# CITY OF WISCONSIN DELLS MEETING AGENDA

## Meeting Description CITY PLAN COMMISSION

**Date:** MONDAY, FEBRUARY 17, 2020 **Time:** 6:00PM **Location:** MUNICIPAL BUILDING  
300 LA CROSSE STREET, WISCONSIN DELLS, WI

JOB NUMBER:  
**2017.31**  
 SHEET  
**C1.0**

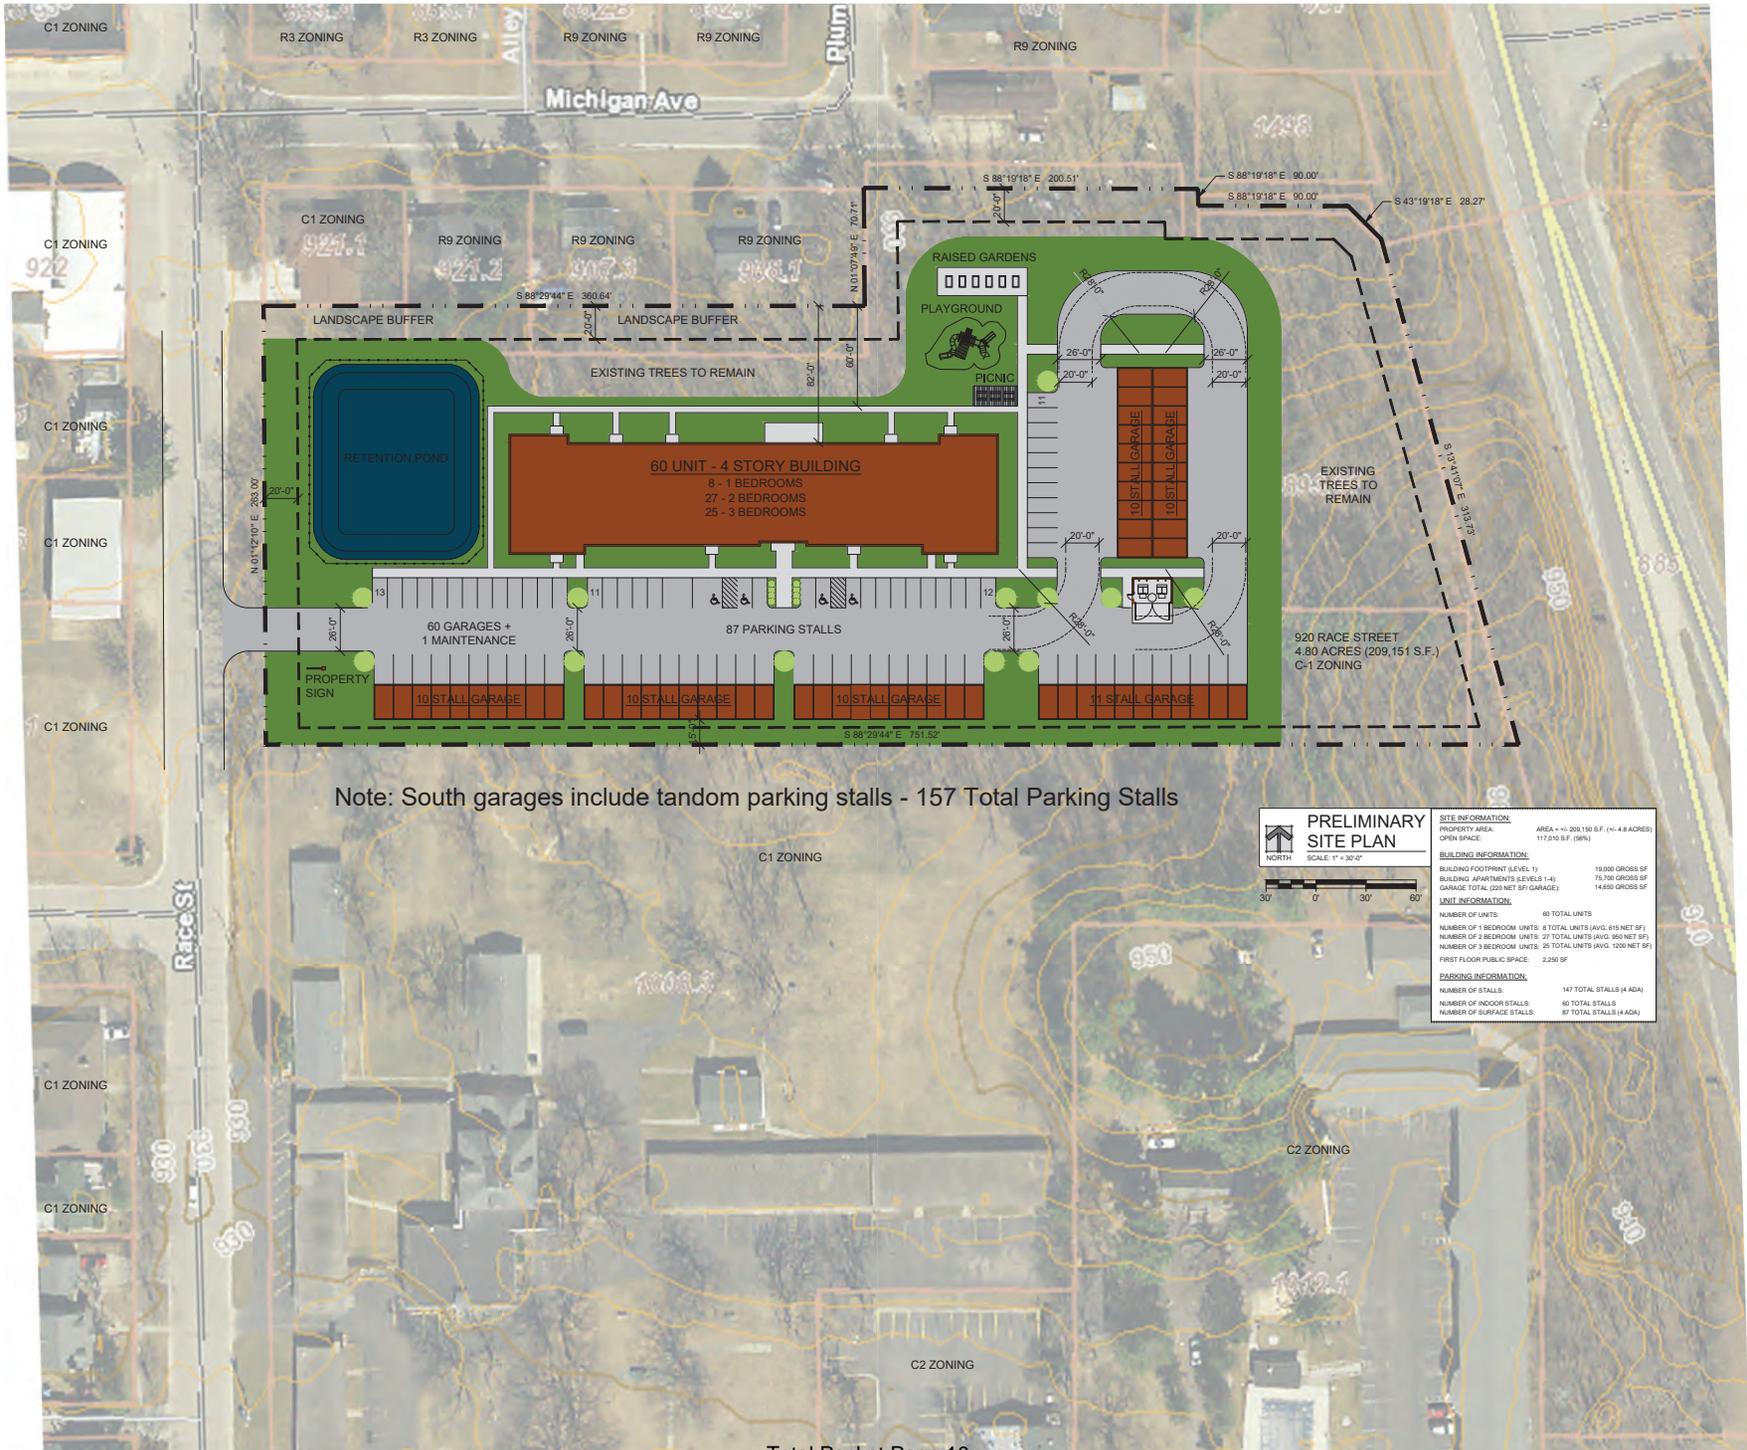
The preliminary site plan that I reviewed shows a single driveway access point off of Race Street between Michigan Avenue and Wisconsin Avenue. Feedback has been solicited from Emergency Services providers but it is my opinion that a second point of access should be required. There are options for this connection to Michigan Avenue off of the north side of the easterly parking area. This second connection would provide options for residents entering and exiting and offer improved access for emergency responders.

Currently there are 108 parking spaces shown between dedicated garage spaces and surface parking spots. This falls short of the City Code requirement of 128 stalls based on the number of units. It appears that additional stalls could be provided at the east edge of the current site plan. The requirement to add these stalls could be held as a future provision in the event that the provided stalls are inadequate.

- Provision of a second access to the site off of Michigan Avenue
- Provision of an adequate landscape buffer between the apartment building and the homes to the north
- Provision of a pedestrian sidewalk from the building to the Race Street right-of-way and along the Race Street frontage of the property
- Provision of additional parking stalls to meet the City requirement or agreement to install added stalls in the event that the currently proposed number are not adequate

**SITE PLAN**  
**ZIP LINE LAYOUT**  
**CHULA VISTA RESORT**  
CITY OF WISCONSIN DELLS  
ADAMS COUNTY, WI

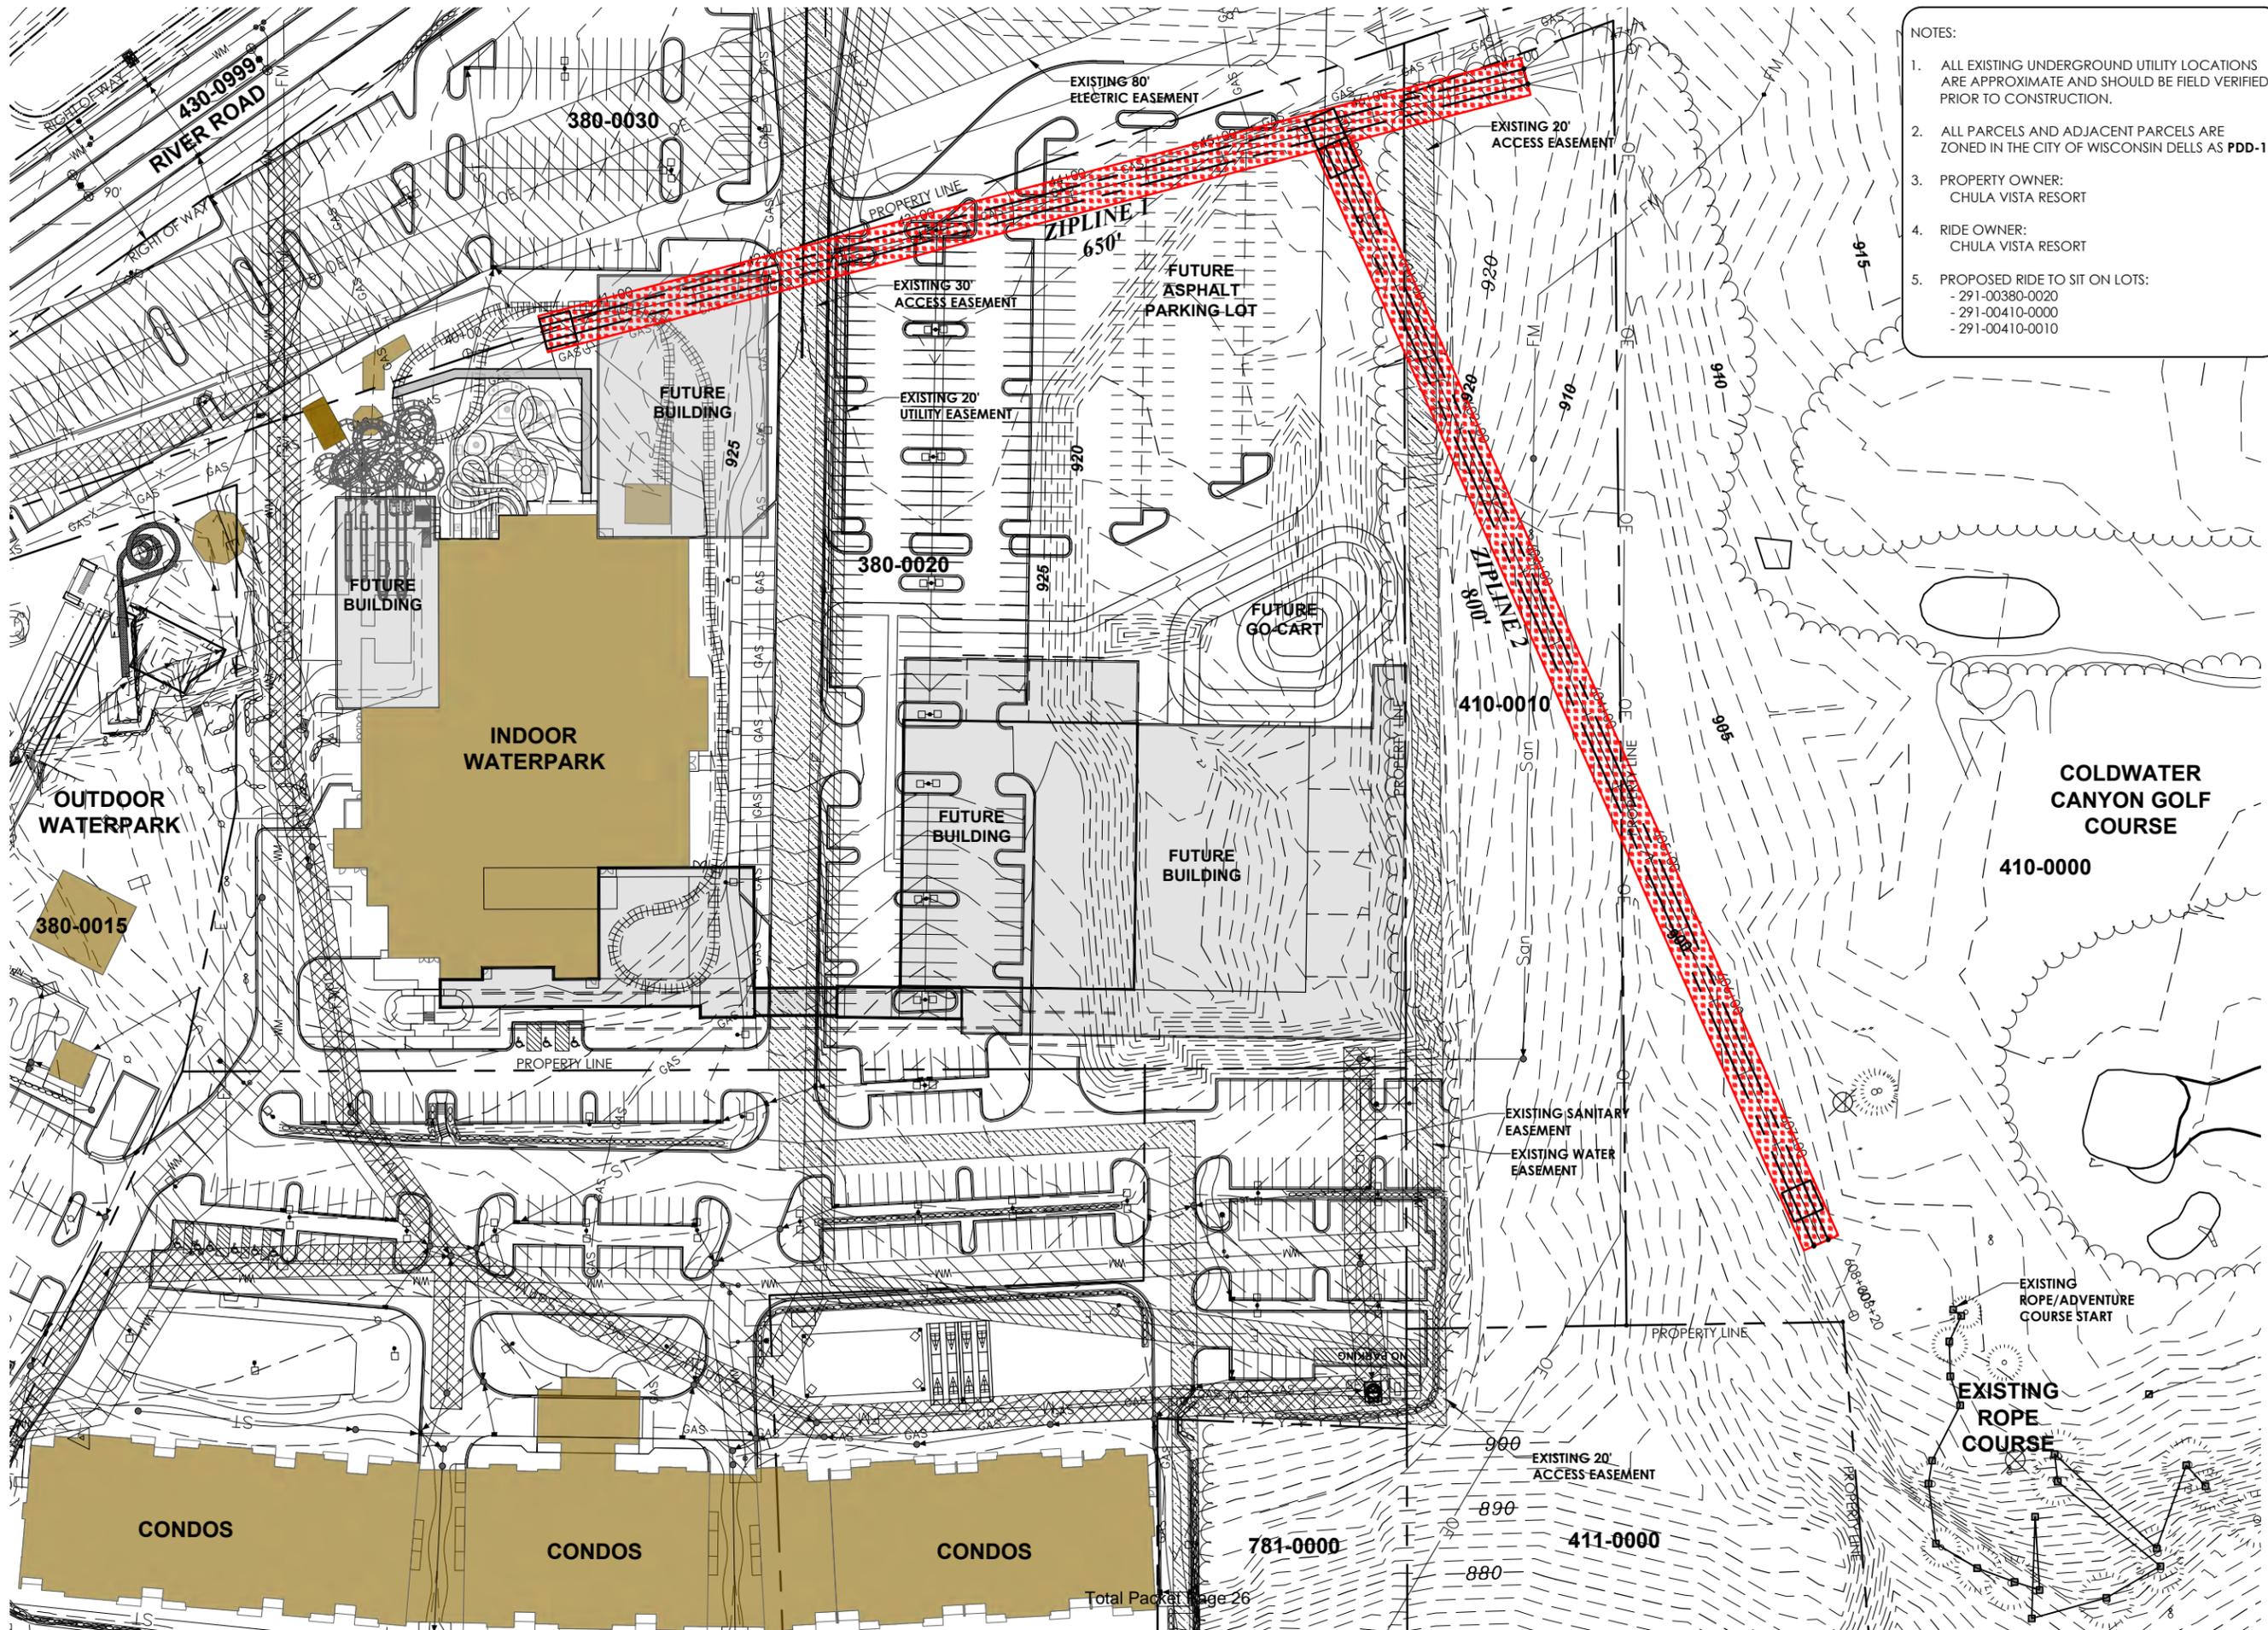
The Zipline ride will involve the construction of a take-off tower on the roof of the Chula indoor waterpark that leads to a landing tower on the ground south of the Chula overflow parking area. This appears to be a fairly open area for the ride. It is noted that there is a overhead electric service line that the Zipline will pass over. The applicant has stated that they intend to remove this line and replace it with an underground service line. Any approval should carry the condition that this conflict be adequately resolved.

The Site Plan submitted indicates the ride would be placed approximately 104ft from the Public Highway Right Of Way (ROW), approximately 60 ft from the overhead electric transmission lines, and approximately 35 ft from the outdoor waterslides.

The City had requested a 90 ft setback from the Wis. Dells Parkway ROW. The plans have been submitted to the American Transmission Company (ATC) who owns and operates the overhead electric transmission lines. Their engineers have reviewed the plan and have confirmed with the City that it is acceptable. The City has contacted DSPS about this ride, and was referred to the administrative code for setback standards around bungee jumps. The DSPS code requires a 30 ft safety set back. The plans for this ride have been submitted to DSPS. The City has not yet received approval from DSPS, but full DSPS approval will be a condition of any City approval. It appears the plans for this ride meets all setback requirements and standards.

7. Zip line is designed and stamped by a qualified and accredited structural engineer
8. The Zip line construction is inspected by the design engineer. The design engineer shall provide a post inspection approval letter to the City

DWG. 819-451 CSM SHEET 1 OF 7

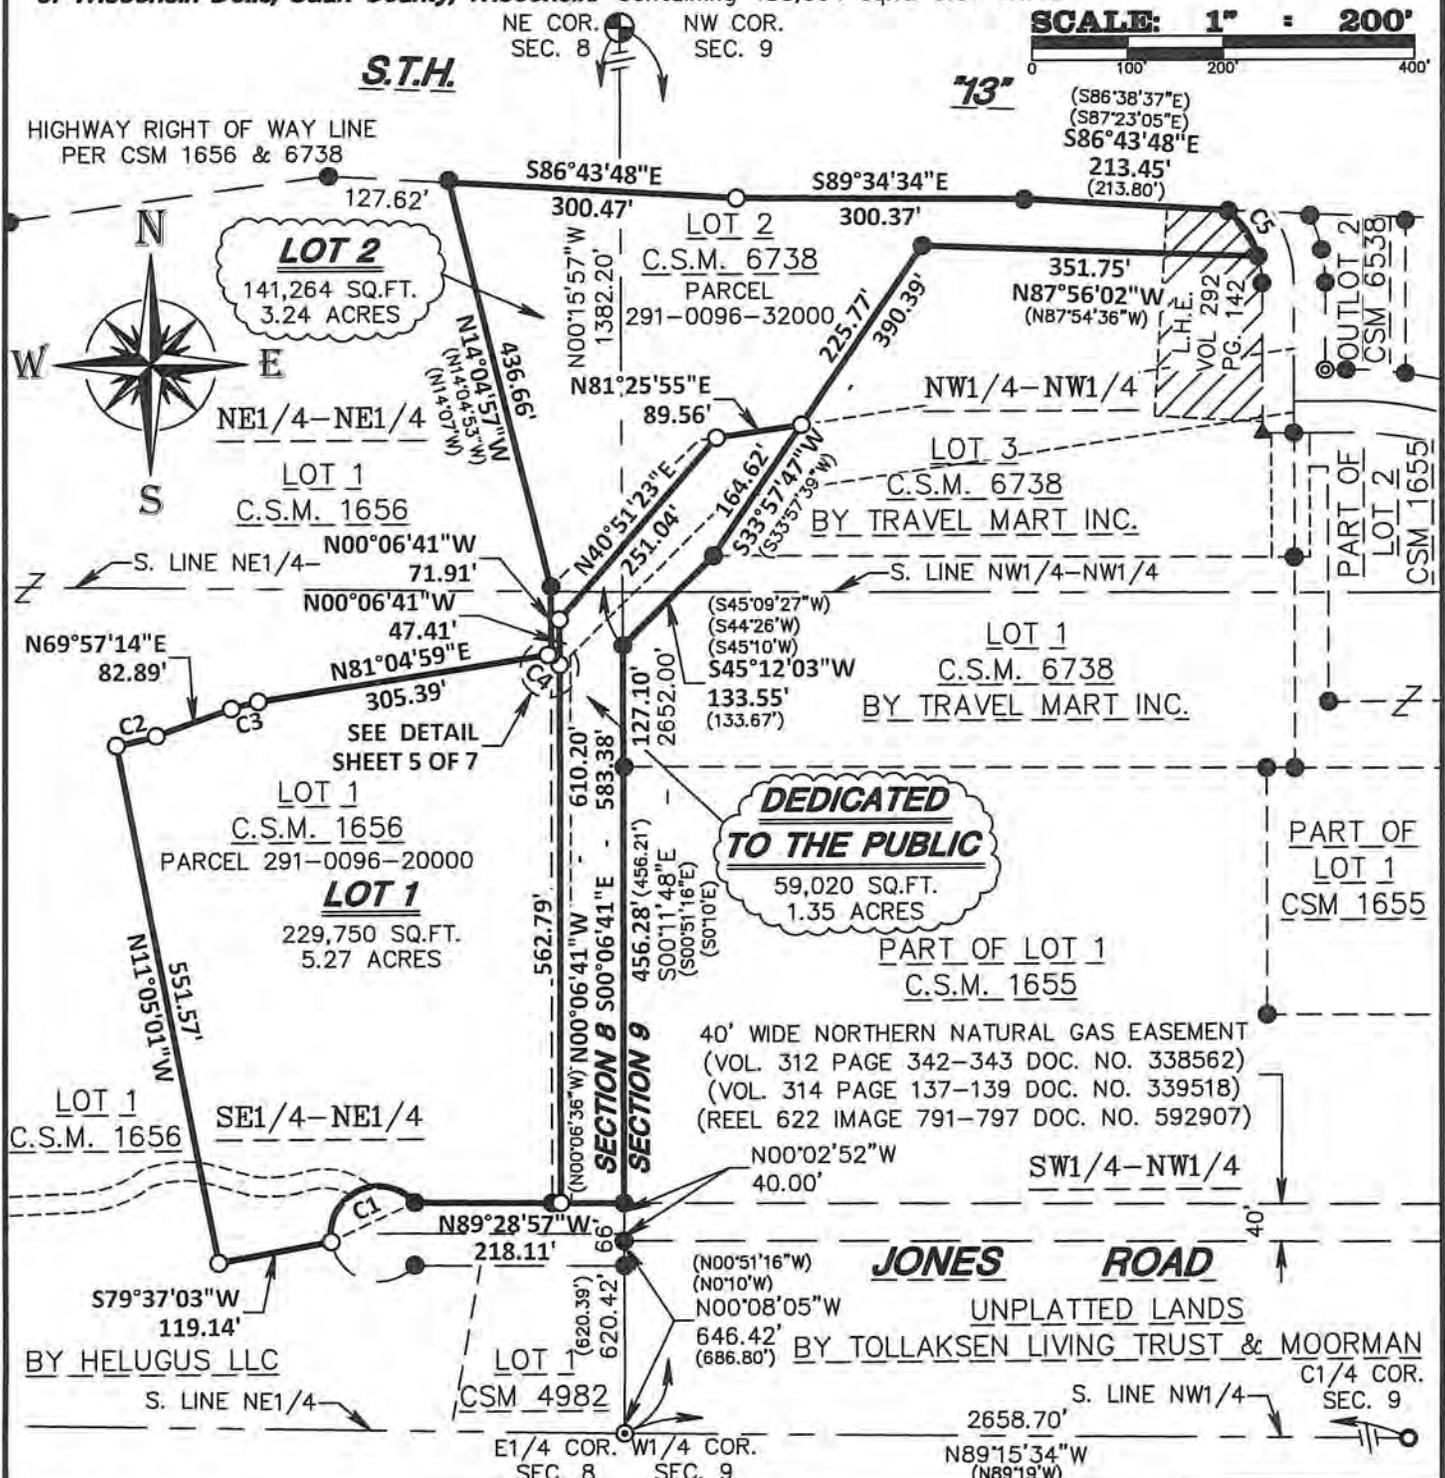
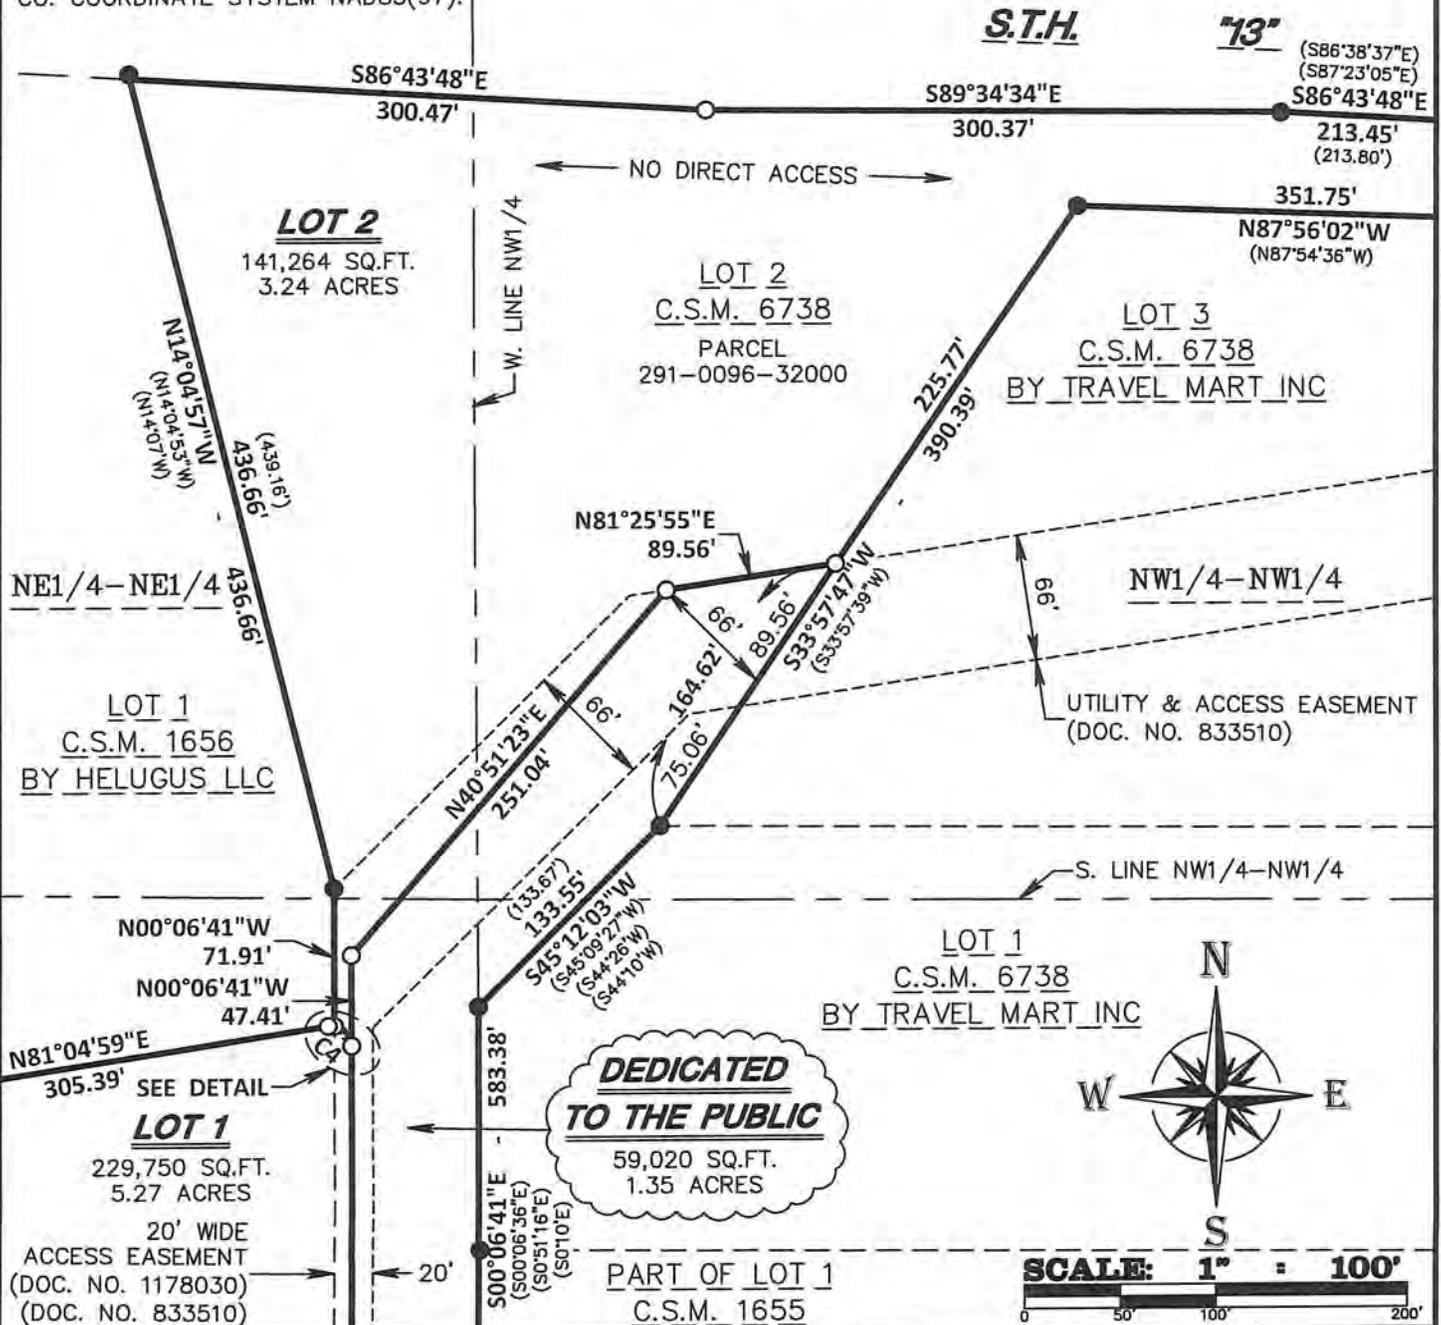
The boundary shown for Lot 2 just north of the northeast corner of Lot 1 forms a narrow strip of land that isolates the remnant parcel to the west from the public right-of-way. It is my understanding that a future road extension to the west has been considered. Either the map should be revised to show the public right-of-way abutting this remnant parcel, or the City should require assurance in the form of a development agreement that access at this location will be allowed in the future.
